ADA Curb Ramp New Construction Inspection Form (Parallel)

Nw 314th ave.

24952.54

Nw. Cottage st

PARALLEL RAMP (PL)

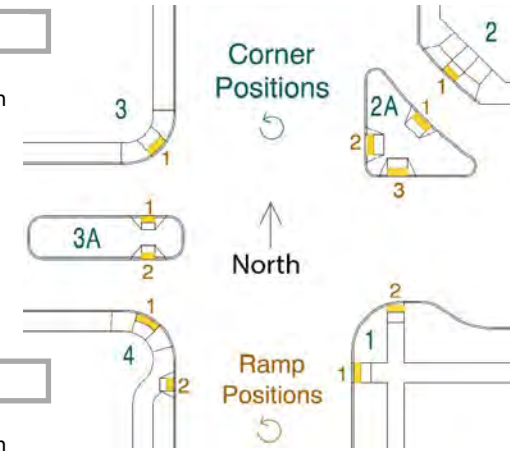
9.4 $\leq 2.0\%$ ☐ $> 2.0\%$ ☒

0.5 $\leq 1/4"$ ☐ $> 1/4"$ ☒

10.5 $\leq |5.0\%|$ ☐ $> |5.0\%|$ ☒

N Y ☐ N ☒

12.6 $\leq 8.3\%$ ☐ $> 8.3\%$ ☒

13.4 $\leq 8.3\%$ ☐ $> 8.3\%$ ☒

No dome, no RR2, no RR3
